DESCRIPTIVE REPORT

Type of Survey HYDROGRAPHIC
Field No. RA-20-02-02
Registry No. H-11139

State ALASKA
General Locality SW Alaska Peninsula and Semidi Islands
Sublocality Semidi Islands - Vicinity of Chowiet Island

Descriptive Report to Accompany Hydrographic Survey H11139

Figure 2. H11139 Junction Surveys

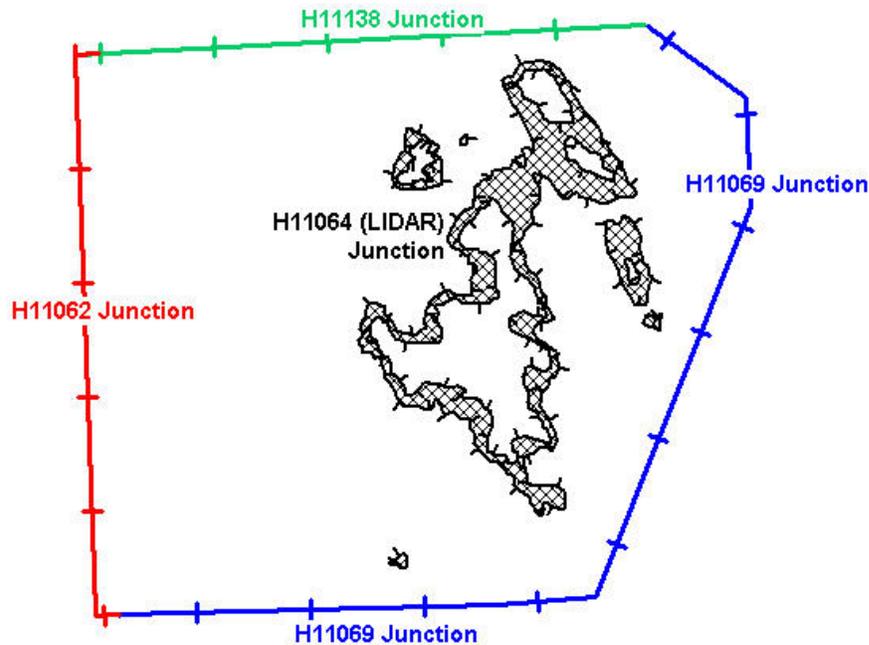
Surveys H11062, H11069 and H11138 junction well with this survey, a cursory comparison indicates differences are generally less than one fathom.⁸

Survey H11064 junctions fairly well with this survey. Generally the soundings were within 2.0 fathoms. Soundings closer to shore ranged from 2.0 fathoms up to 5.0. In a few instances

larger differences were found. This can be attributed to the steep irregular bathymetry near shore.⁹

One LIDAR sounding 1.099 fathoms at $56^{\circ}05'17.830''N$, $156^{\circ}40'46.330''W$ (644377.29E , 6218332.51N) was at the junction of H11139 and H11064. A feature was found and half was covered with SWMB. The shoalest sounding found on H11139 in the area was 10.694 fathoms. In addition, during the initial single beam and visual inspection nothing was found.¹⁰

One holiday ($56^{\circ}03'15.270''N$, $156^{\circ}41'05.320''W$ (644176.22E , 6214533.55N)) was found post-processing at the junction of H11064 and H11139. The section that is not covered by LIDAR or SWMB is a down sloping area between 28 and 39 fathoms.¹¹ From the rejected outer beams no significant feature is obvious.¹²

⁸ Concur.

⁹ Concur with clarification. LIDAR soundings from H11064 were placed on Level 20 of the smooth sheet to complete coverage of near-shore areas.

¹⁰ Concur. At chart scale the feature abuts the shore and is not depicted in the Hdrawing. The evaluator considers the survey data inadequate to disprove the feature, and it is depicted on

the smooth sheet.. It is recommended that the feature receive further investigation as resources allow.

¹² Do not concur. Review of the data indicated that coverage was inadequate to confirm that there were no features in the area. It is recommended that the area receive further investigation as resources allow.

¹³ The junction with surveys H11062, H11064, H11069, and H11138 are complete; soundings and depth curves are in good agreement within the common area. A “Joins” note has been shown on the smooth sheet where applicable.
